Item 13 Meadow Way Bridge Replacement Project

Supplement to Attachment H

Written Public Comments Received

TECHNICAL MEMO REVIEWING Final Initial Study/Mitigated Negative Declaration for the Meadow Way Bridge Replacement Project

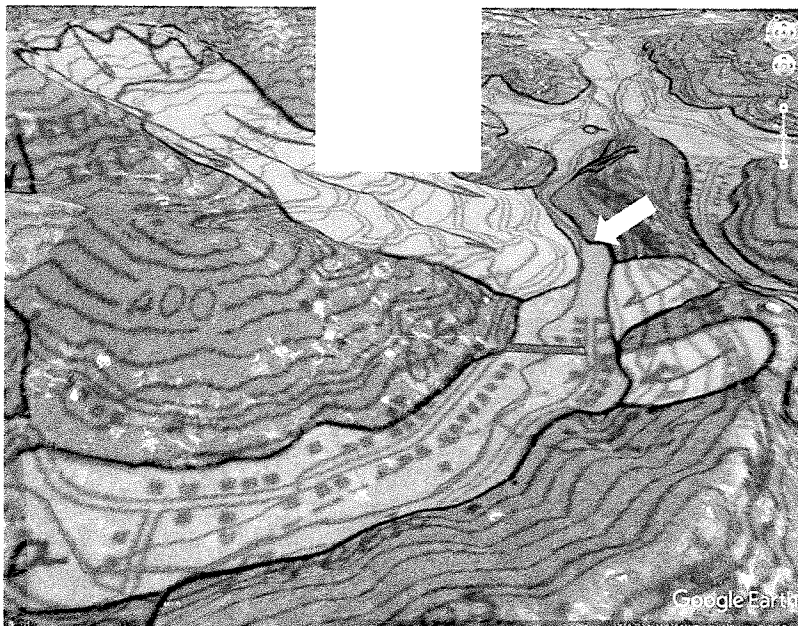
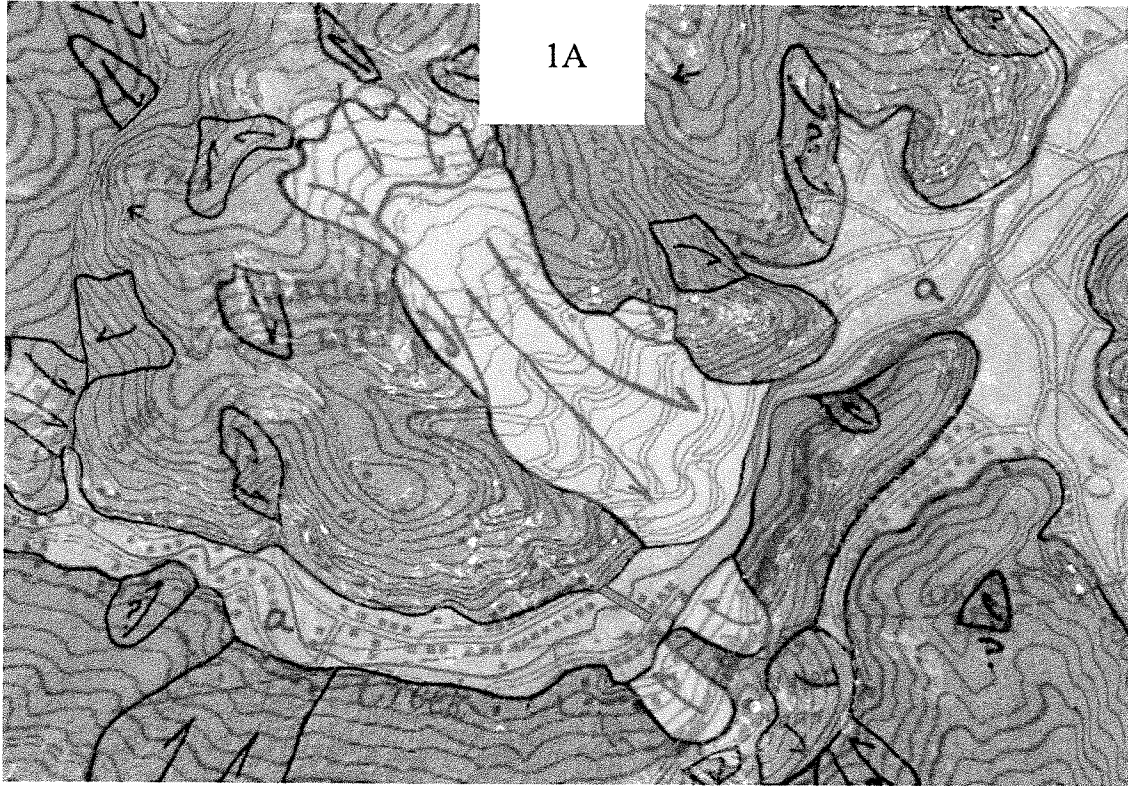
The MND does not appear to take into account the Project’s location near debris slide run-out pathways or the proximity of rotational and/or translational landslides along the adjacent hillsides that could put the Project site at risk from potential disruption from uphill slippage. There are off-site but very nearby landslides that could pose on-site impacts. The toes of the two landslides on the southern adjacent hillside have been mapped by Wentworth and Frizzell (USGS, Open File Map 75-281, sheet 11, 1975) (see Figures 1A and B). These slide features appear to be roughly 150 feet from the south side bridge abutment and extend over 400 feet in length from the edge of the alluvial valley to the ridgetop. The USGS map is online at the link below.

Further, a very large complex landslide, that extends over 3000 feet from ridge top to valley bottom is just downstream of the Project site (its western lateral scarp is about 300 linear feet downstream of the north bridge abutment on the north hillside and its movement at some time in the geologic past was sufficient sometime in the past to block the entire creek and cause backwater alluvial deposition that created the existing landscape of the Project site where now, a much wider alluvial valley exists upstream of the landslide pinch point. The MND provides no discussion or analysis about the existence of these slides or prospect of their future impacts during a large seismic event or extreme rainfall. If a prior large landslide created the alluvial valley that the bridge is sitting on, the MND’s characterization of this area as ‘flatland’ for purposes of landslide impact analysis is misleading and cannot be supported as free of potential geologic hazards.

The 1975 USGS landslide map indicates that the northeast abutment is not necessarily on alluvial sediments, yet the MND provides no information whether the abutment is on or near bedrock or the condition of the bedrock that exists. The MND does not explain whether the abutment is concordant with bedrock at depth on the other side or if there is evidence of faulting between the bridge abutments as could be possible due the presence of the fault that is mapped nearby, nor does it provide any information about the actual subsurface condition here and what is the known depth and condition of bedrock at the site. In my opinion without this information, the MND's impact assessment is inadequate as it fails to address the potential for impacts that could occur from severe seismic shaking from the large San Andreas and Hayward Fault systems as well as offset and sheared rock conditions from local mapped faults as well as landslides. Local faults and landslides can mechanically weaken the bedrock by shearing it, cracking it, and thereby weaken the strength of the bedrock to support structures. If either side of the bridge abutment is in different types of soil or bedrock structural design must be developed to suit the different conditions. Proximity of faults and landslides is a red flag to needing subsurface and off-site investigations to build safe structures that require piers for support.

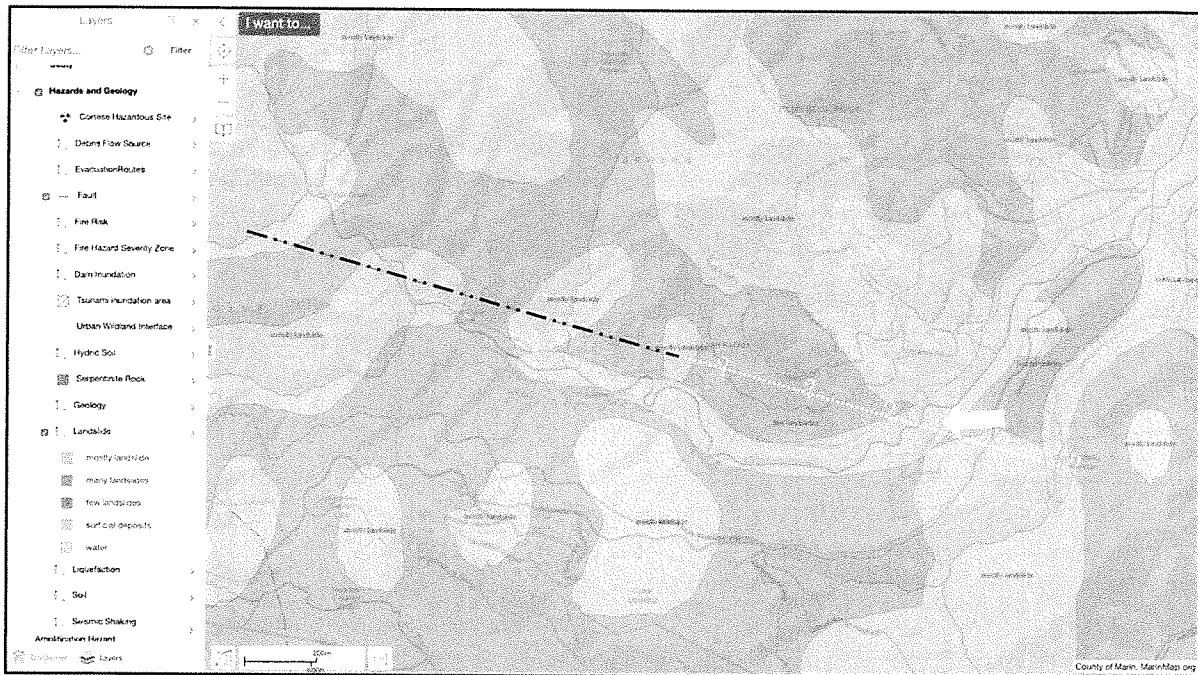
Interpretation of landslide conditions by Wentworth and Frizell is supported by recent landslide hazard classification shown online at the MarinMap Viewer, as shown in Figure 2. The current online map (as shown 5/2020) characterizes much of the watershed to be landslide prone. The area of large northern slide, as indicated by the earlier USGS mapping, is shown as mostly landslide and the extent of the toe is much closer to the Project site than previously indicated (about 150 linear feet as opposed to 300 feet. This suggests that recent landslide interpretation finds the extent of landslide hazard to be bigger yet there is no discussion of the reason for the differences in interpretation which could relate to possible recent landslide activity or more thorough investigations nearby.

Compounding this, the MND fails to describe accurately the seismic issues in the Project area, only concluding instead that the project site is not located within a State-designated Alquist-Priolo Earthquake fault rupture zone. In addition to the landslide hazards, the MarinMap Map Viewer (herein referred to as MarinMap) also shows a distinct northwest trending fault about 2200 feet to the northwest of the site. The MND fails to describe the fault or its southeastern projection into the footprint of the Project. This fact that they do not reference this source of information is even more bewildering given that they reference MarinMap as a source of GIS and environmental information. The importance of the fault should be evaluated relative to potential effects on the weakness of sheared and mechanically weakened bedrock at the site and for the potential for vertical or lateral offset during a large magnitude earthquake from the San Andreas Fault system. How the proposed structural design elements of the proposed bridge and piers may or may not be appropriate at this site must be evaluated given the unresolved presence of sheared bedrock due to either the projection of this fault or from

underlying landslide debris. In my opinion, the influence of the fault and its status must be established to avoid negative impacts to expected longevity of the bridge and risk to human life during a large seismic event associated with severe shaking from the San Andreas Fault. The MarinMap is online at the link below.
